**T  
E  
C  
H  
N  
I  
C  
A  
L  
T  
I  
P  
S**

**– July 1992 –  
#30**

TECHNICAL TIPS #30  
JULY 1992

MAIN DRIVE GEAR SPACER/ SEAL CHANGES

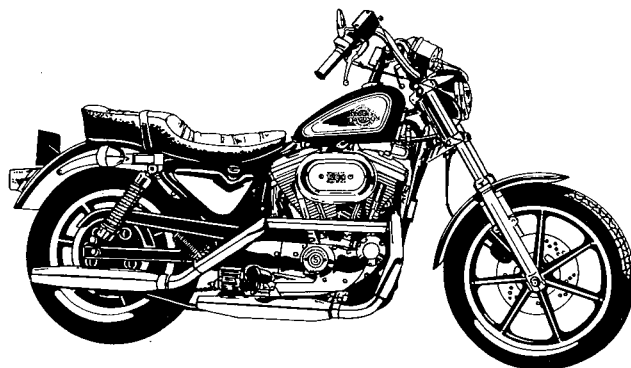
The diameter of the Main Drive Gear spacer, p.n. 33334-85 has been increased for greater surface contact against the main drive gear bearing. This also changes the main drive gear seal, p.n. 12050.

The two new parts must be used as a pair and cannot be intermixed with old parts. The parts are not hard to identify, the diameter change was so great, (approx. - .250"), that it would be pretty hard to mix up old and new.

Main Drive Spacer/ Seal Kit	33334-85A
contains:	
Main Drive Gear Spacer	33344-92
Main Drive Gear Seal	12067

## ALTERNATOR ROTOR FASTENERS

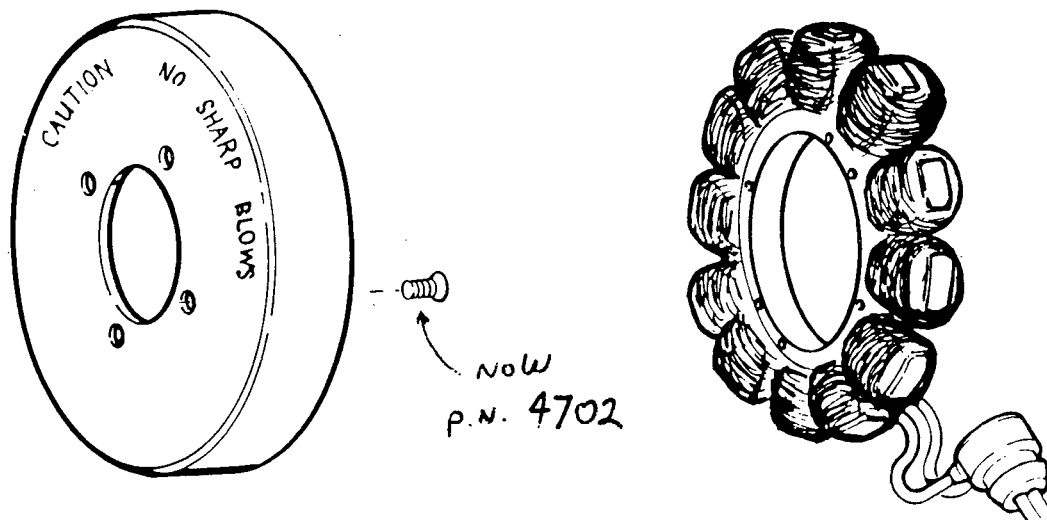
The fasteners that secure the alternator rotor to the engine sprocket are changing. The countersunk Allen fasteners, p.n. 41191-74, will be changed to hex bolts, p.n. 4702.

The new rotor assembly with the new bolts can be ordered under part number p.n. 32403-89A

The bolt torque specification is still 90 - 110 in./lbs. and Loctite 242 is used.

## OIL PUMP DRIVE GEAR CHANGE

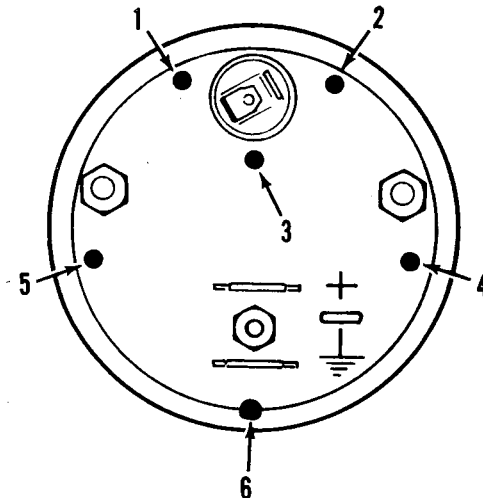
A material change to cast iron for increased service life was implemented on April 23, 1992.

The new gear has a part number change to 26318-88A. This part will retrofit to all Sportster models, 1988 and later.
